## Technical Note TN-723

# Modifying the Transmit deviation of the T3000-4500 Plug-in CTCSS board

1<sup>st</sup> July 2002

This Technical Note applies to the T3000-4500, which is a plug-in CTCSS option board for the T3030, T3035 and T3040 MPT1327 Trunked Dispatch portable radios.

## Top view of the CTCSS board

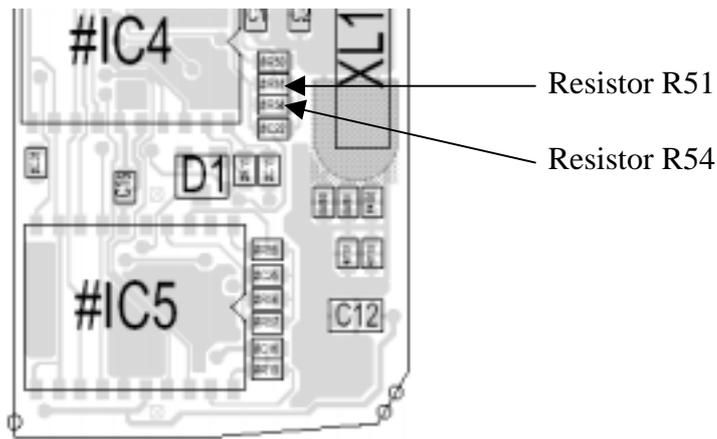
The T3000-4500 CTCSS option board fitted to MPT1327 Trunked T3000 model radios only generates about 150 and 180 Hz deviation of CTCSS sub-audible tone.

The specification for CTCSS Transmit level is 15% of full system deviation. On Narrow Band systems ( $\pm 2.5$  kHz) the CTCSS level should be between 280 and 380 Hz.

The CTCSS level on the option board is fixed by component value and cannot be altered by software.

To increase the output level, change two parallel resistors on the option board, **R51** and **R54**, to the values 100 k $\Omega$  and 1 M $\Omega$  respectively.

These values should give an output of about 340 Hz deviation.

If a more specific output level is required, some fine adjustment can be made by altering the 1 M $\Omega$  resistor value.

For example increasing R54 to 2M2  $\Omega$  will produce about 380Hz.

Resistors R51 and R54 are found on the top of the printed circuit board next to IC4. See the circuit board enlargement on the next page.
